September 2018
FL768AB
NHTSA #18V-250 School Buses
#18V-378 Non-School Buses
Transport Canada #18-197

Subject: FCCC Bus Chassis Battery Cable Interference

Models Affected: Freightliner Custom Chassis B2 school bus chassis (Thomas Built Buses Saf-T-Liner C2) and S2C shuttle bus chassis manufactured March 10, 2017, through March 6, 2018.

Fig. 1, Incorrect Battery Cable Installation

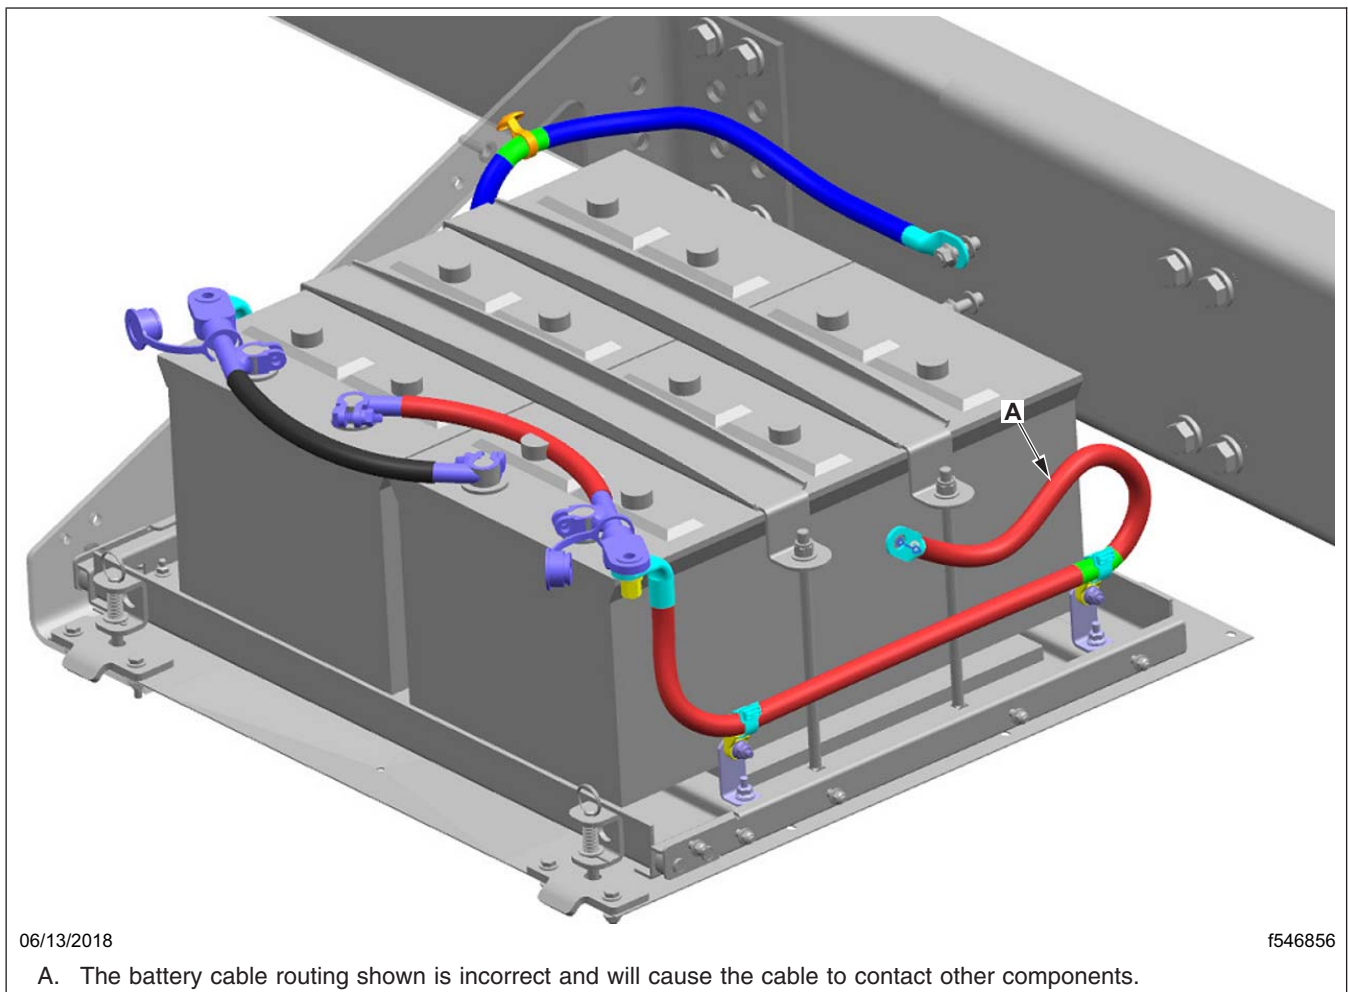
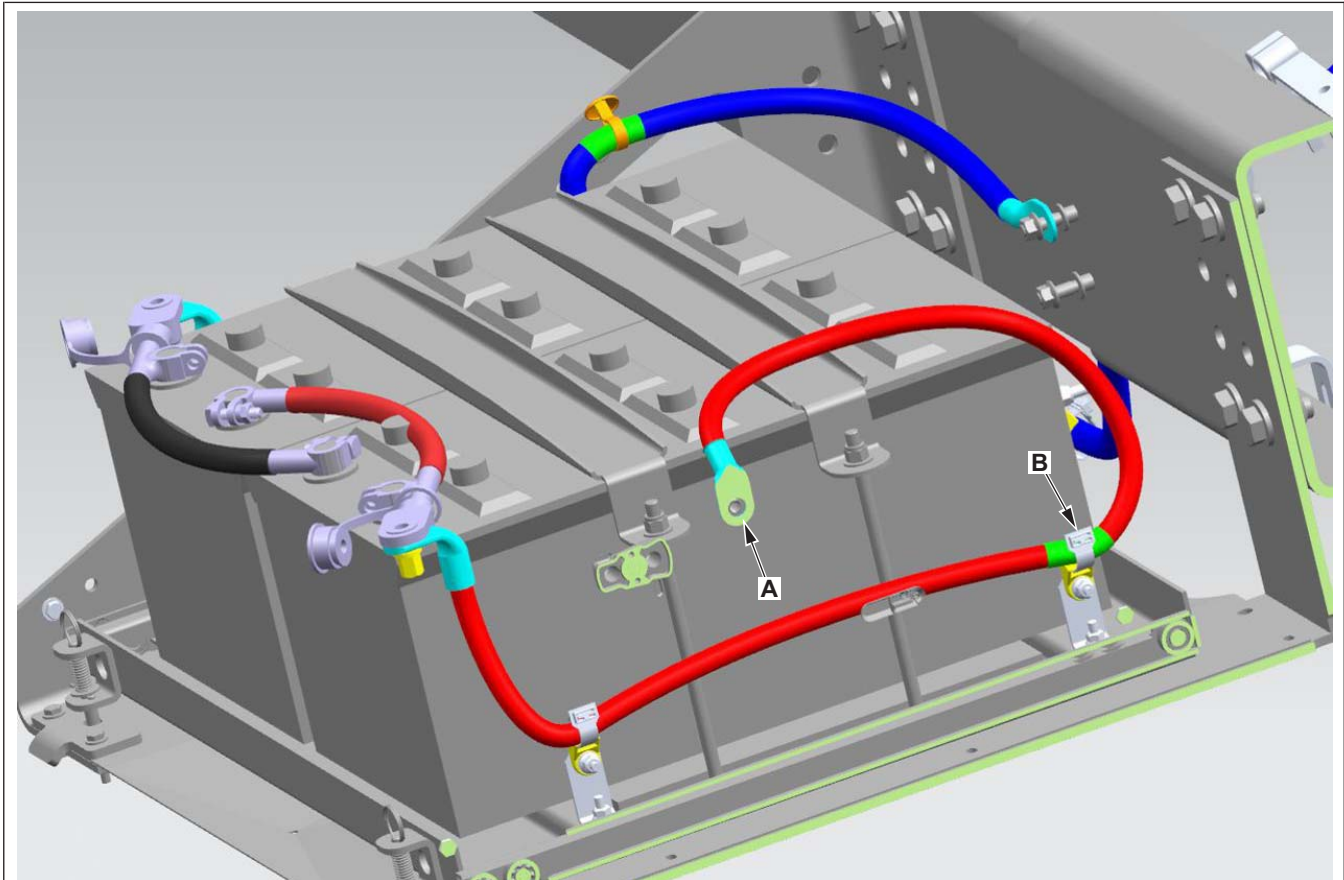
On certain vehicles, a battery power cable may be routed with inadequate clearance between the cable and a battery hold down bracket. This reduced clearance may cause the cable to rub against the hold down bracket, potentially damaging the cable and leading to arcing, which may increase the risk of a fire.

1. Check the base label (Form WAR259) for a completion sticker for FL768 (Form WAR260) indicating this work has been done. For school buses, the base label is usually located above the driver's window. For shuttle buses, it's usually located in the driver's area. If a sticker is present, no work is needed. If there is no sticker, proceed with the next step.
2. Park the vehicle on a level surface, shut down the engine, and set the parking brake. Chock the tires.
3. Inspect the battery cable for correct orientation. There must be a minimum of ½ inch (13 mm) between the cable and the battery hold-down bracket and stud when sliding the battery tray in and out. **Fig. 1** shows an incorrect battery cable installation. **Fig. 2** shows the correct battery cable installation.

- 3.1 If the battery cable is installed correctly, no further work is needed. Go to step 7.
- 3.2 If the battery cable is not installed correctly, inspect the cable for damage. It is possible for the conduit that covers the battery cable to be damaged, but the battery cables themselves are not damaged. Damage to the battery cables could include, but is not limited to, a cut in the battery cable or visible cable insulation. If the **battery cable** is damaged, go to 'Battery Cable Replacement.' If the cable is not damaged, but requires proper orientation, go to the next step.

- A. Rotate the end of the battery cable to an approximate 11 o'clock position.
B. Align the tape on the battery cable with the saddle mount.

4. With the battery tray pushed in, use a wrench to loosen the nut on the battery cable at the power distribution module (PDM) stud.
5. Rotate the end of the battery cable as shown in **Fig. 2**, then tighten the nut 26 lbf-ft (35 N-m).

6. Slide the battery tray in and out to verify the battery cable does not rub the battery hold-down bracket or stud.
7. Clean a spot on the base label (Form WAR259). Write the recall number, FL768, on a blank red completion sticker (Form WAR260), and attach it to the base label to indicate this recall has been completed.
